Application No. A.21-07-012

BEFORE THE
PUBLIC UTILITIES COMMISSION
OF THE STATE OF CALIFORNIA

GOLDEN STATE WATER COMPANY

REBUTTAL TESTIMONY

I-20 Same as Photos I-18 and I-19, except a closer view of the stand-off support brace and u-bolt.

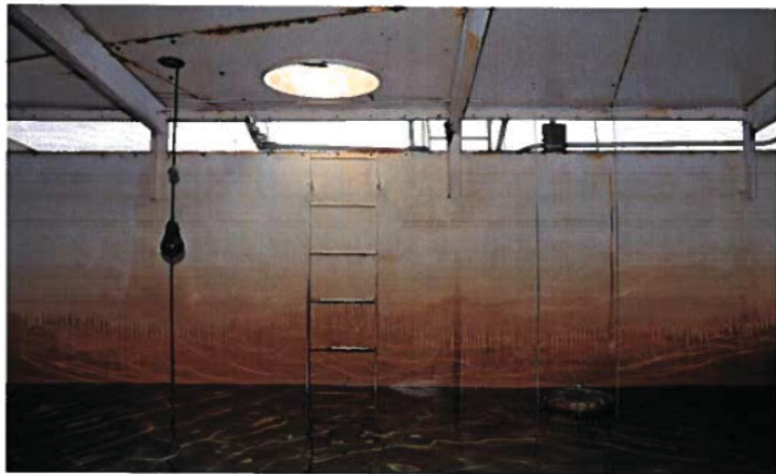
The 2017 Harper & Associates report also states nine recommendations for structure modifications for safety, health and the compliance of Cal/OSHA regulations and two more rehabilitation recommendations.²²¹
